V2500-A5/D5 SERIES PROPULSION SYSTEM SERVICE BULLETIN

This document transmits the Revision 2 of Service Bulletin V2500-ENG-73-0220.

V2500-ENG-73-0220

ENGINE – FUEL AND CONTROL – PRESSURE BURNER SENSOR PORT SCREEN DELETION**1. Planning Information****A. Effectivity****(1) Airbus A319****Engine Models Applicable**

LOCATION AND REMOVAL OF THE PRESSURE BURNER SENSOR PORT
SCREEN BY AN OPERATOR
FIGURE 3, SHEET 1

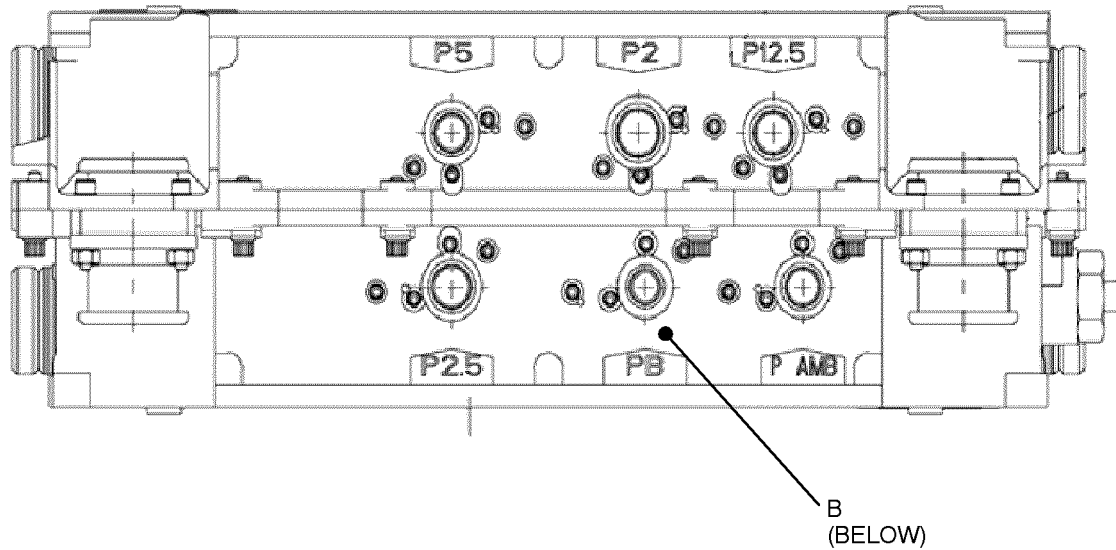
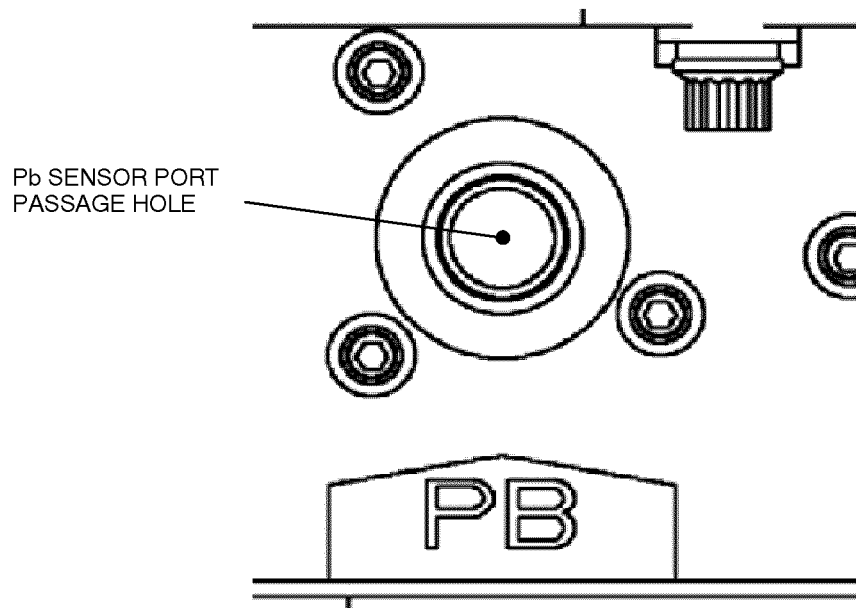
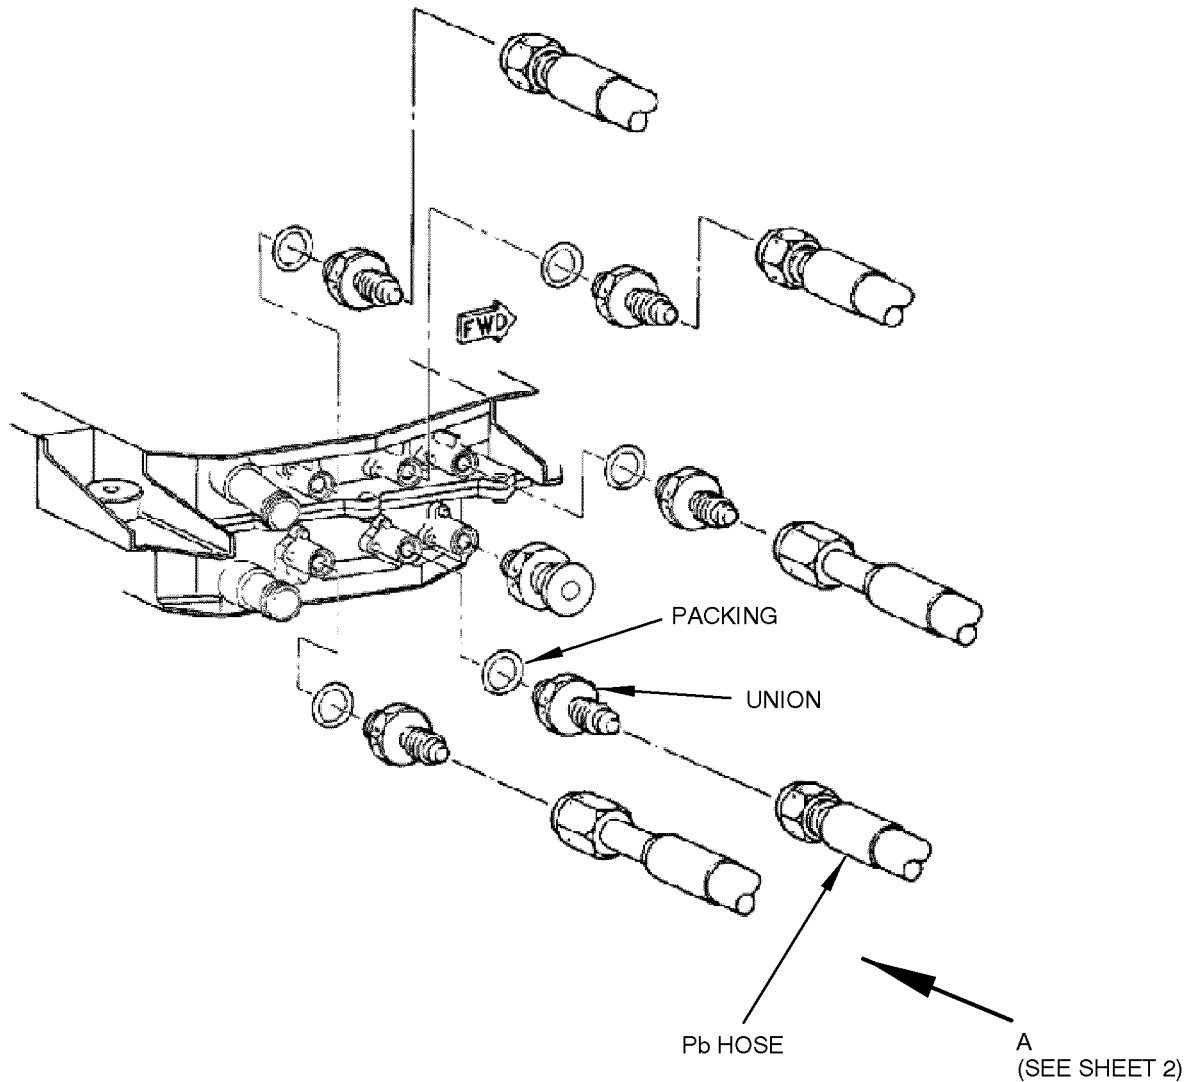
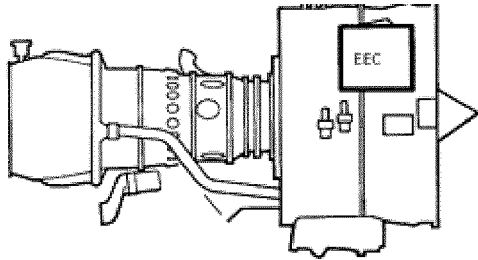
- (6) Remove the wire that safeties the Pb hose and union in Figure 3, Sheet 1.
 - (7) Disconnect the Pb hose from the union.
 - (8) Cap the Pb hose to prevent FOD from occurring.

- (13) Locate the Pb sensor port passage hole. See Figure 3, Sheet 2 for the location of the hole.
 - (14) Use a Snap-on® Pick, PN SG3ASH45BR or equivalent and approach the Pb sensor port passage hole with the pick point as close to passage center as possible. Pierce the center of the screen with the pick point while holding the pick at the required angle to orientate the pick point perpendicular to the screen. If necessary use a small light weight plastic tipped mallet to lightly tap the end of pick handle to initiate the screen piercing.

- (15) Once the screen is pierced, slowly rotate the pick in a clockwise direction as inward pressure is applied. Once the angled prick point is beyond the screen, 0.500 in. (12,700 mm) maximum, slowly apply outward force on the pick to assure screen is hooked. Repeat as required to hook the screen. Once the screen is securely hooked continue outwards force to remove screen.

- (22) Install a new Packing, PN NAS1595-4, shown in Figure 3, Sheet 1, onto the union. See Reference 11, Airbus Aircraft Maintenance Manual, Task 70-23-13-911-010 or Reference 10, Boeing Aircraft Maintenance Manual, Task 70-23-13-918-801.

LOCATION AND REMOVAL OF THE PRESSURE BURNER SENSOR PORT
SCREEN BY AN OPERATOR
FIGURE 4, SHEET 1

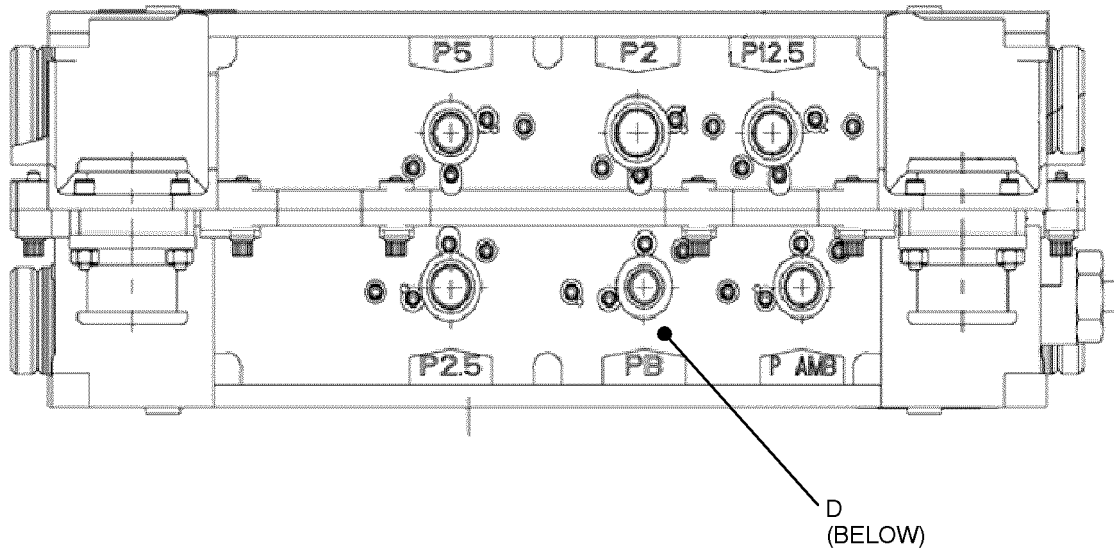
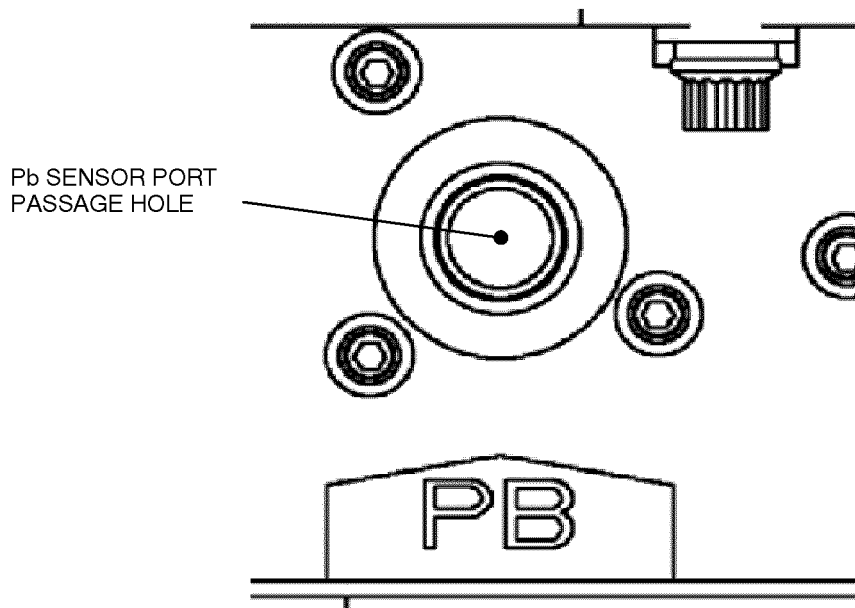
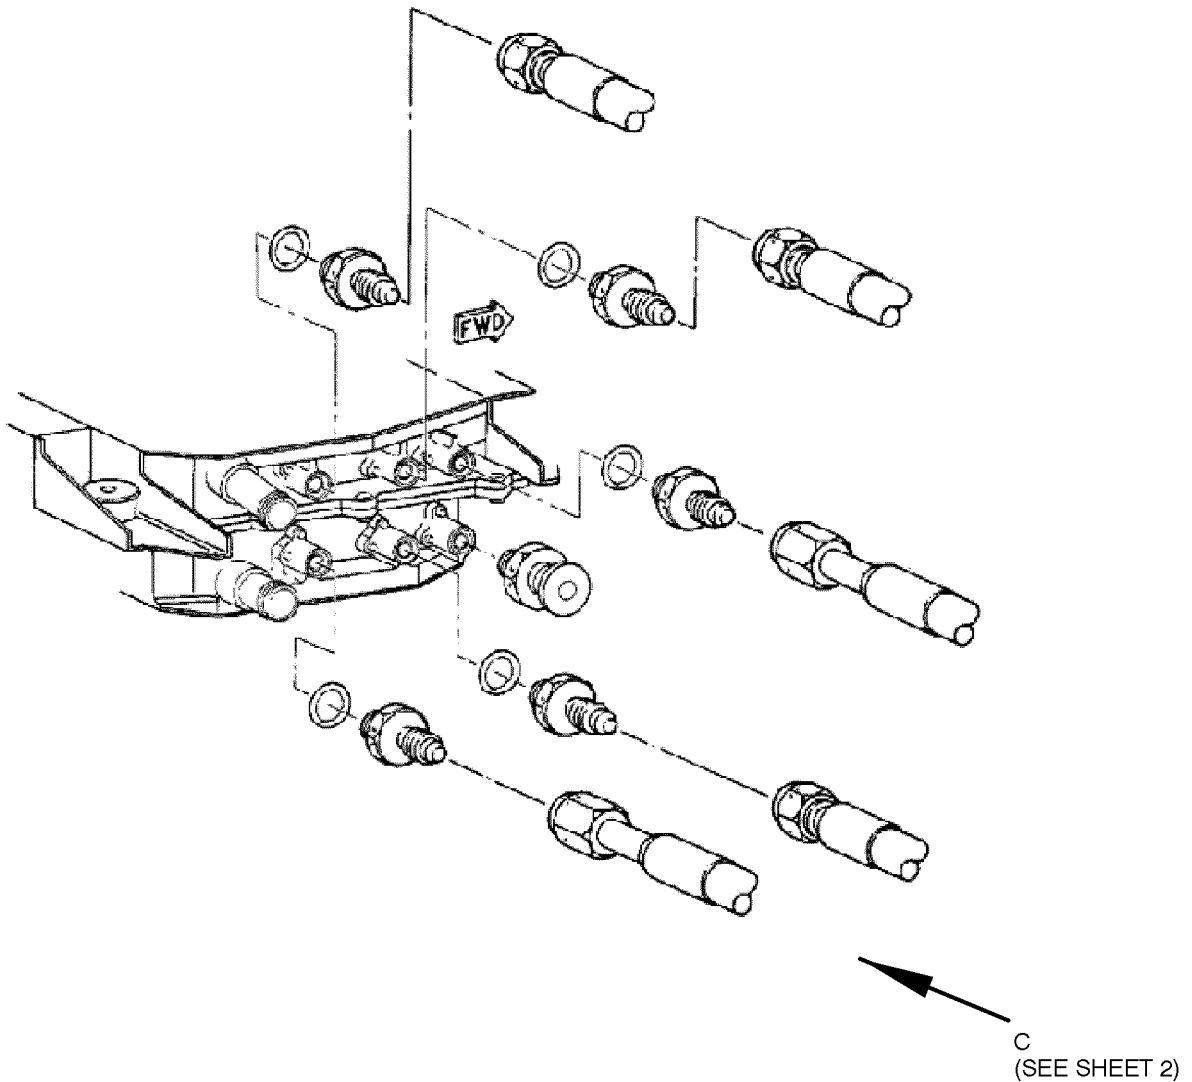
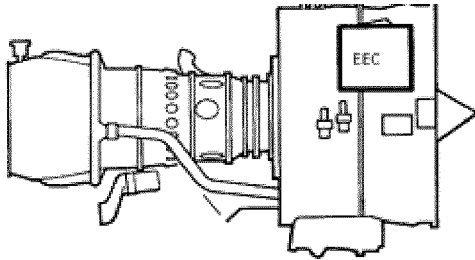
- (2) Visually examine the Pb sensor port to obtain a "baseline" for the condition of the EEC Pb sensor port outer sealing face surface and threaded internal surfaces.
- (3) Locate the Pb sensor port passage hole. See Figure 4, Sheet 2 for the location of the hole.
- (4) Use a Snap-on® Pick, PN SG3ASH45BR or equivalent and approach the Pb sensor port passage hole with the pick point as close to passage center as possible. Pierce the center of the screen with the pick point while holding the pick at the required angle to orientate the pick point perpendicular to the screen. If necessary use a small light weight plastic tipped mallet to lightly tap the end of pick handle to initiate the screen piercing.

- (5) Once the screen is pierced, slowly rotate the pick in a clockwise direction as inward pressure is applied. Once the angled prick point is beyond the screen, 0.500 in. (12,700 mm) maximum, slowly apply outward force on the pick to assure screen is hooked. Repeat as required to hook the screen. Once the screen is securely hooked continue outwards force to remove screen.
